**BID: CC-35
Benson and Klein Street Parking Lot**

**ADDENDUM 1
Dated: November 22, 2021**

**BENSON/KLEIN
PARKING LOT**
COLLETON COUNTY
118 BENSON STREET
WALTERBORO, SC 29488

**LANDSCAPE
PLANTING PLAN/
PARKING AREA**

L103

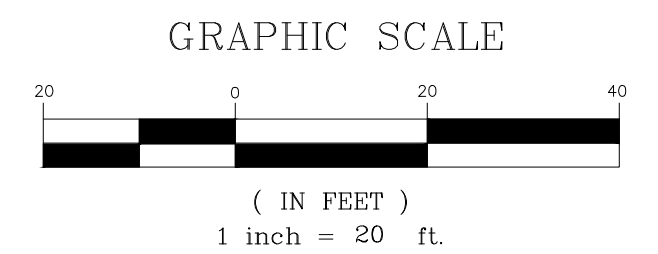
1. The landscape plans note steel edging – can you verify where steel edging is supposed to be installed? What size steel edging? **Answer:** Steel Edging 4” height x 1/8” thick, nominal 16’ lengths with 14”-16” metal stakes. See attached Drawing for location.

EDGING NOTE:
DARK BROWN STEEL
EDGING B/W PLANTED AREA
AND LAWN

**LOCATION OF STEEL
EDGING approx. 90LF**
